Comments Report: Blast Impact Assessment

Bundu Mining (Pty) Ltd

Rietvalei Mining Right Application Project

1.3 Comment 02:

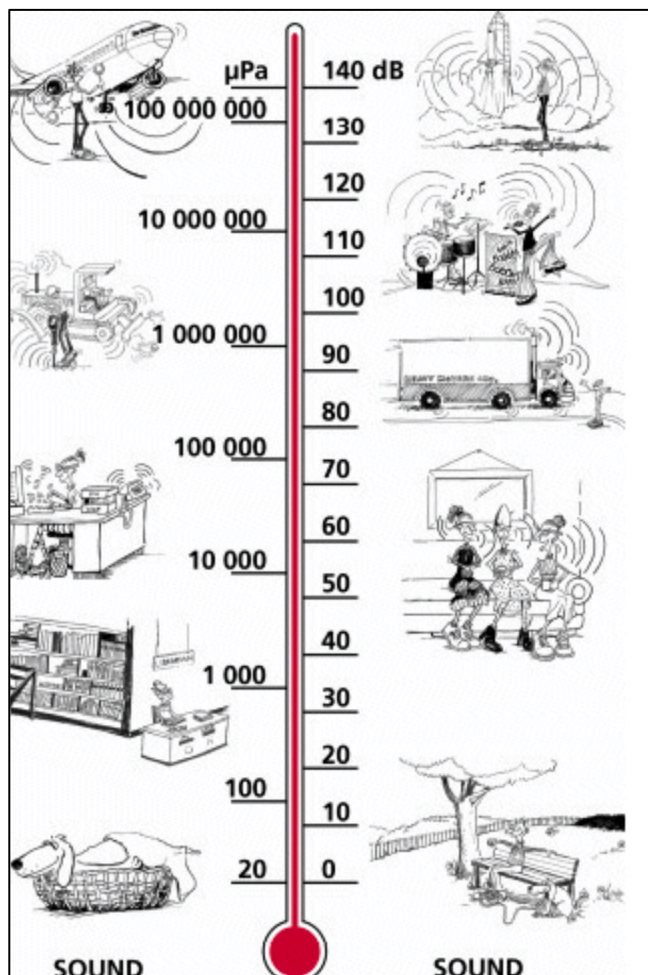
Ms Alet du Preez said they have been breeding with parrots which are a registered endangered specie since 2007. According to the breeding agreement the location of breeding could not be changed. In order to achieve this the mine may not conduct blasting activities during July to December, which is the breeding time of the parrots. What solution can be proposed as it was not easy to register the breeding program. Mr Zeeman said it has been noted and an investigation will be done and feedback given. Located at 20 Loots St.

The house / comment made in question refers to location marked in BMC reports as POI 98. This structure is located 1013 m from the nearest point of the pit. The expected levels of air blast is 124.1 dBL for the maximum charge evaluated.

Firstly I need to qualify that the air blast level referred to is the air overpressure that may be caused by the blast. This is not the noise level. This pressure also occurs for a very short fraction of time – at the peak of the spike maybe a few milliseconds. This air blast is also part of the inaudible shockwave (less than 20 Hz – human ear does not hear sounds less than 20 HZ). Apart from the air

blast, yes there is also a noise component. Any blast done also generates some noise. This noise is however very difficult to predict due to a significant number of variables that have influence on the sound level. This sound is also of short duration. How would it influence animal life? Blasting done properly is not a sudden “bang” event like the crack of thunder lightning or the firing of of a shotgun. Blasting is a rumble noise effect. Using a guideline calculation it is expected that a 124.1 dBL air blast level may lead to a sound level of 84.6 dB(A) for a short period of the blast. Please note this is a rough guideline. This level is similar to that of a truck moving or farming equipment operating. See the guideline below.

There has been a significant number of studies done with regards to birdlife, too many to list here. No specific study that I have seen addresses the effect of blasting on parrots. So it is a bit of a grey area what influence can be expected. In comparison if we use chicken as example the reaction to blasting is also variable. In some cases the chickens did not show any major reaction – lifted their heads and then continued grazing, some cases did show the chickens scramble a bit and then continued grazing. The main concern remains that proper blast best practices must be applied. This means proper stemming controls ensuring that all blastholes are stemmed with the correct material and the correct stemming length. This controls the effect of air blast and the noise generated.

Animal life also habituate to the noises that occurs in the area. In many case birds will just do that. Blasting will not necessarily chase birds away.

I am of the opinion that if blasting is done with proper attention to best practices the effect at a distance of 1013 m where the house is would be minimal. Recommendation would be that specific monitoring should be done at this location and possible reactions of the birds monitored.
